RE: Planning Application 3/2021/0397 (Land at Barrow Brook Enterprise Park, Barrow, BB7 9QZ)

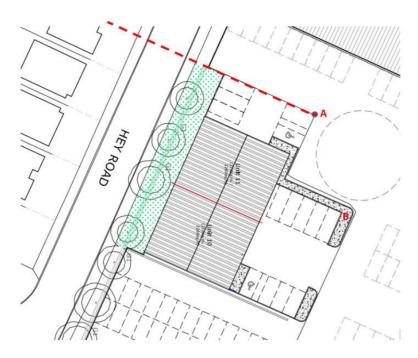
The proposed unit, which is "roughly" 16.5 meters deep plus a 24m distance to the nearest residents totals 40.5m. There is also a mottled grey area I have marked as B, which I presume is curbed landscaping giving a total of over 41m. However, from point A - which I have marked on the image below - measures 40.361m to the nearest house (measured using an industrial laser along the dotted red line). Therefore, the developers cannot build the project 24m from the nearest property to their specifications of 16.5m in depth and meet the required 24m. Taking this all into account, we suggest that an accurate assessment of the proximity to the nearest neighboring occupants would be closer to 23m if measured to the houses and therefore will not meet the required building regulations for fire and safety.
